Upton & 43rd Street Station

Changes based on draft plan feedback

Linden Hills Neighborhood Council, Business Subcommittee
February 23, 2022

Feedback received on the draft plan

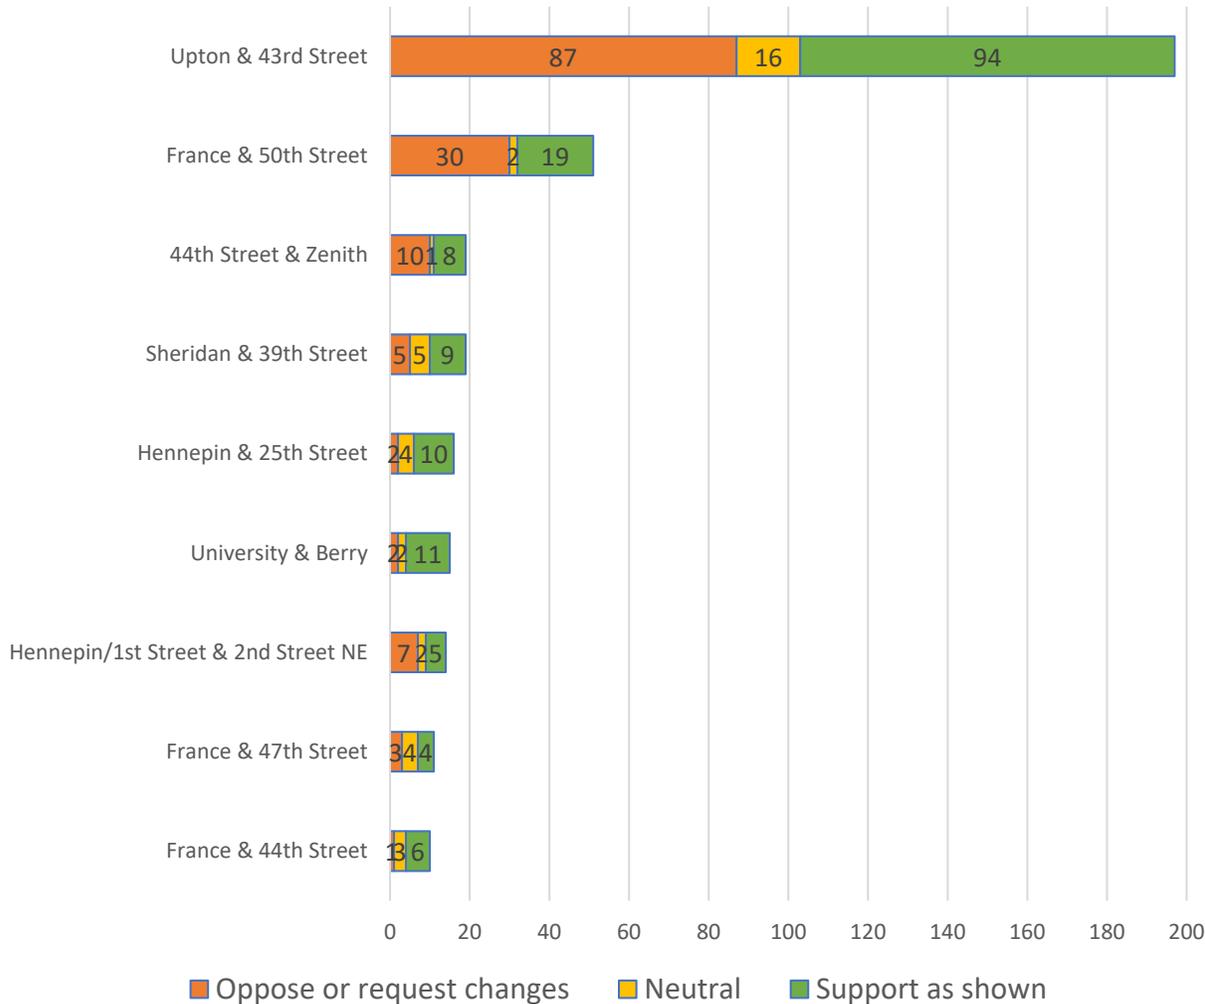
- 197 emails and comments on this station location
- 87 opposed or requested changes, 94 supported as shown
- Common supporting themes:
 - Improved customer waiting facilities
 - Convenient access to commercial district
 - Improved frequency, speed, and reliability of service
- Common opposing themes:
 - Removal of on-street parking and boulevard trees
 - Bus and traffic operations
 - Impact on storefront visibility and fit within neighborhood character

Changes to platform locations in recommended corridor plan

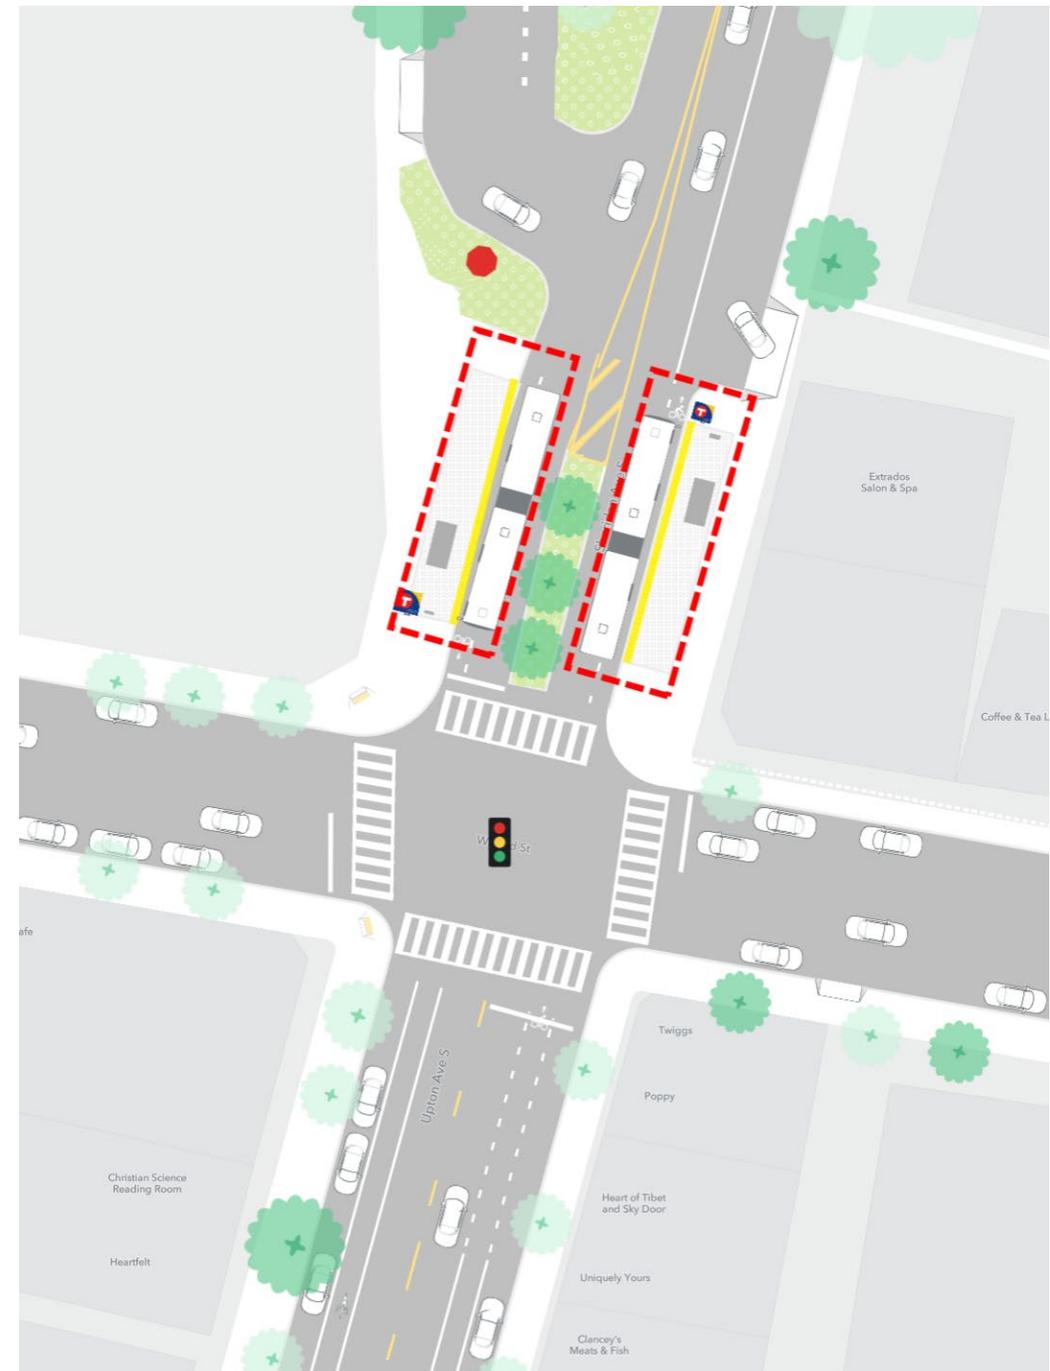
- Additional alternatives analyzed based on draft plan feedback
- Shift southbound platform from farside (southwest) corner to nearside (northwest) corner
- No change recommended to northbound platform

Additional southbound alternatives analyzed

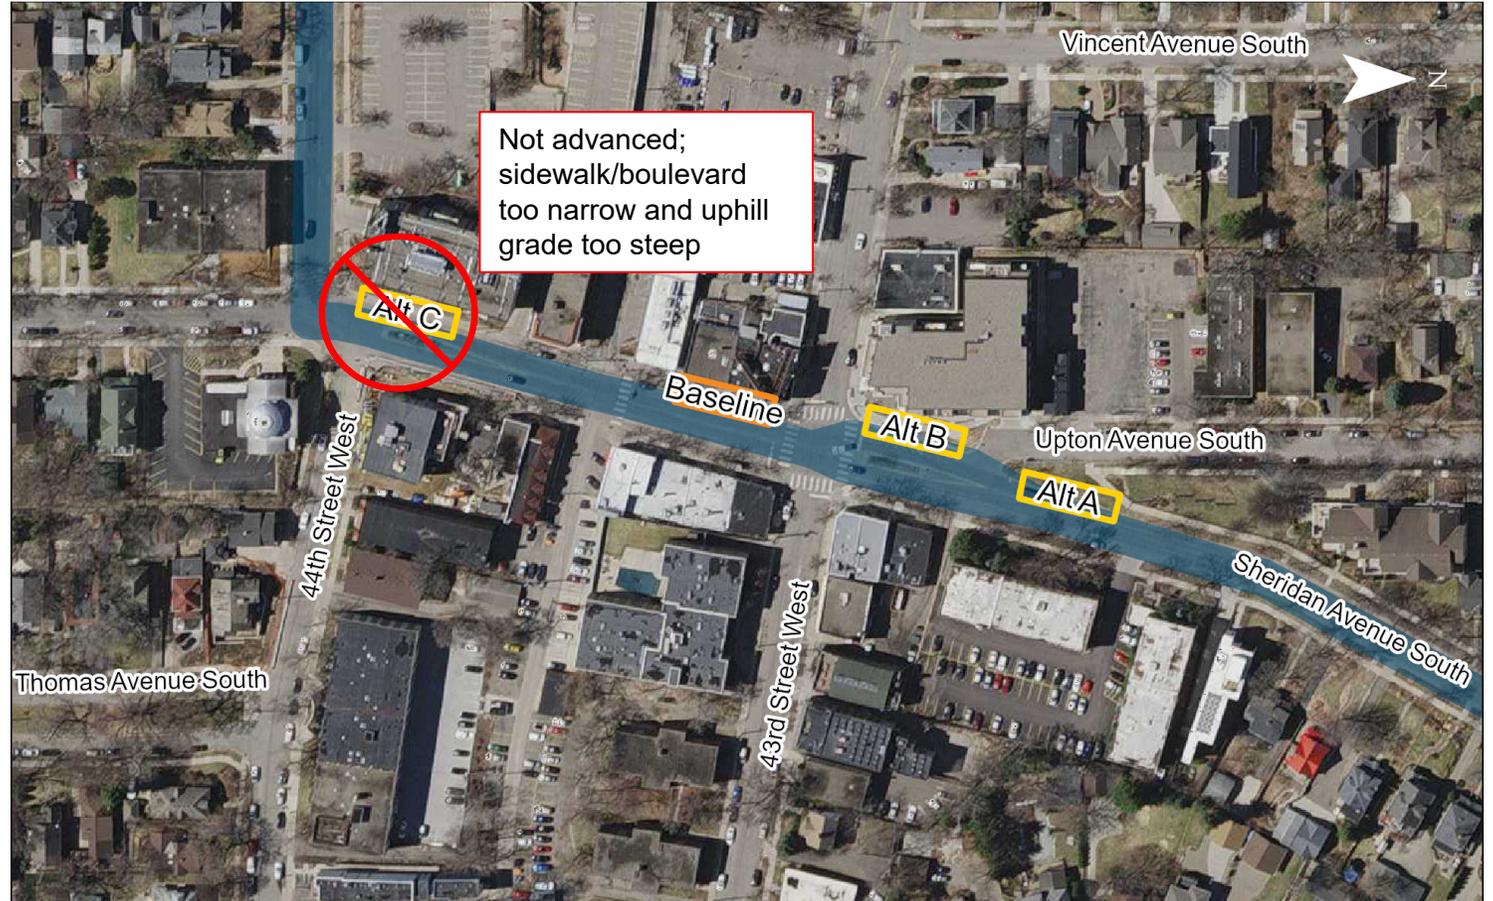
- **Baseline Location:** Upton Ave and 43rd St farside
- **Alternative A:** Sheridan Ave and 43rd/42nd St midblock
- **Alternative B:** Upton Ave and 43rd St nearside
- **Alternative C:** Upton Ave and 44th St nearside
 - not advanced

Additional northbound alternatives analyzed

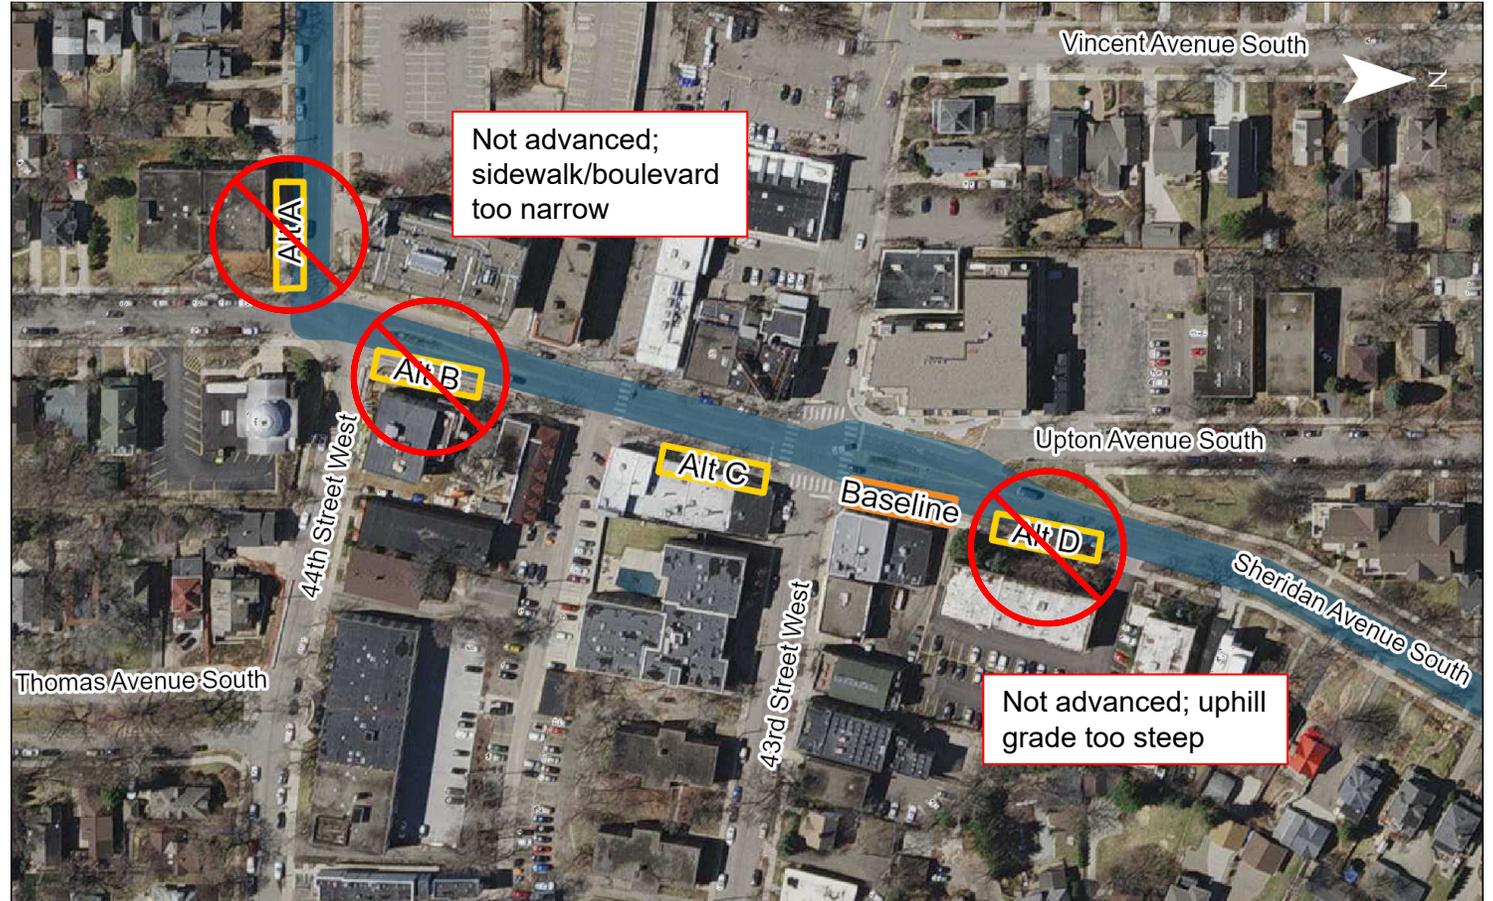
- **Baseline Location:** Upton Ave and 43rd Street farside
- **Alternative A:** 44th St and Upton Ave nearside
 - not advanced
- **Alternative B:** Upton Ave and 44th St farside
 - not advanced
- **Alternative C:** Upton Ave and 43rd St nearside
- **Alternative D:** Sheridan Ave and 43rd/42nd St midblock
 - not advanced

Changes to platform locations in recommended corridor plan

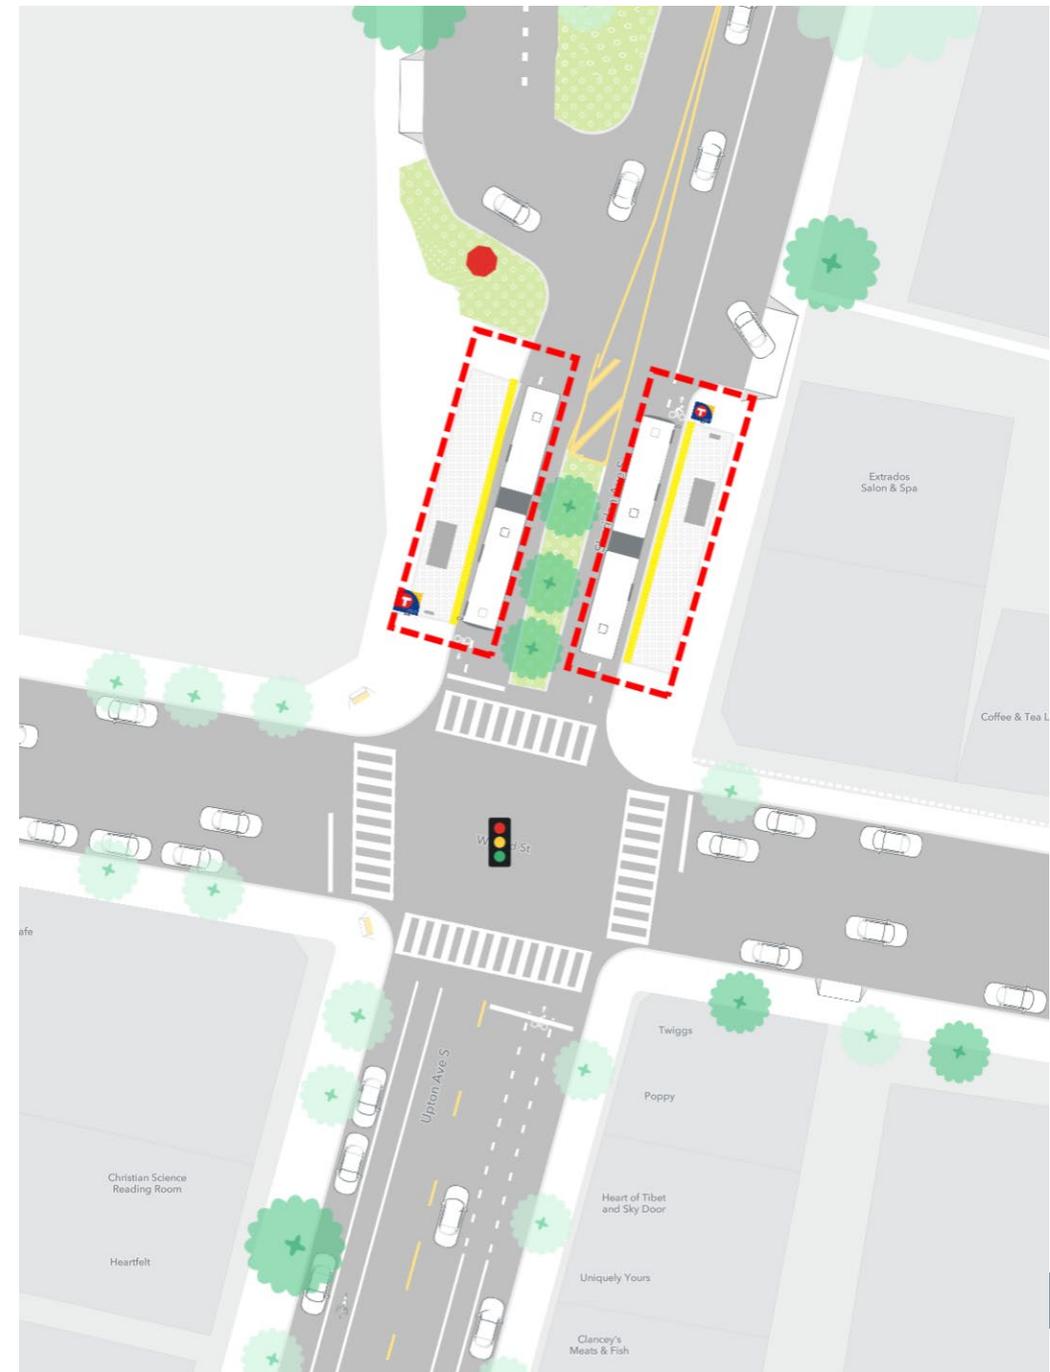
- Reduces reduction in on-street parking spaces from 7-8 spaces to 3 spaces
- Reduces potentially disturbed boulevard trees from 7-8 to 4 trees (station design will include preservation or replacement)
- Reduces potential effects on storefront visibility
- Maintains convenient access to commercial district
